Silicon revision mask N58A, N13J, N65K, MC24XS4 and MC36XSD errata

This errata document applies to the dual 24 V - 36 V high-side switches family.

Document Number: MC24XS4ER

Figure 1. Proposed off time sequence

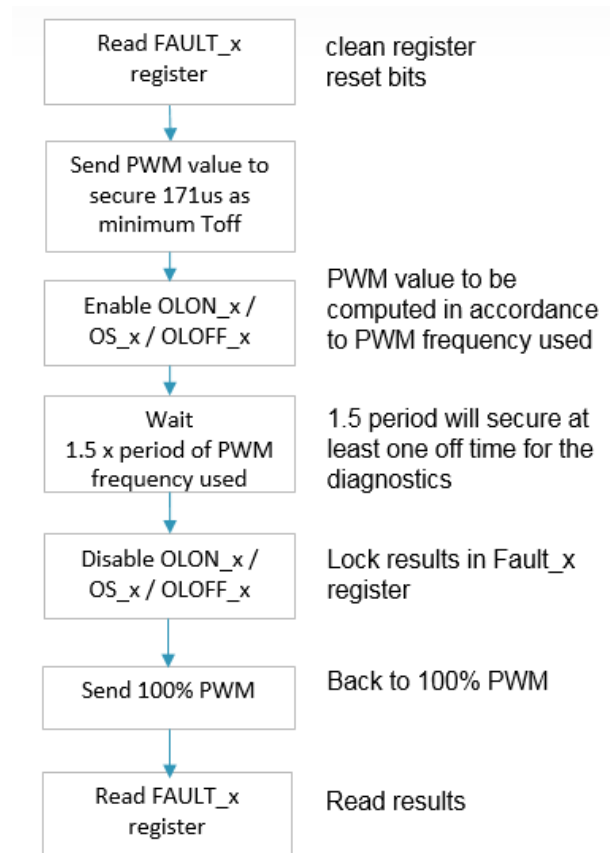
ER06 – Open load detection in low current mode 100% duty cycle

When running the device in 100% PWM mode, the open load detection can be corrupted in Low-current mode (CSNS_ratio_s=1).

The device returns a short to battery instead of open load.

A 171 μ s minimum OFF time is recommended to be sent by the ECU for robust open load detection. A proposed sequence is shown in [Figure 1](#).
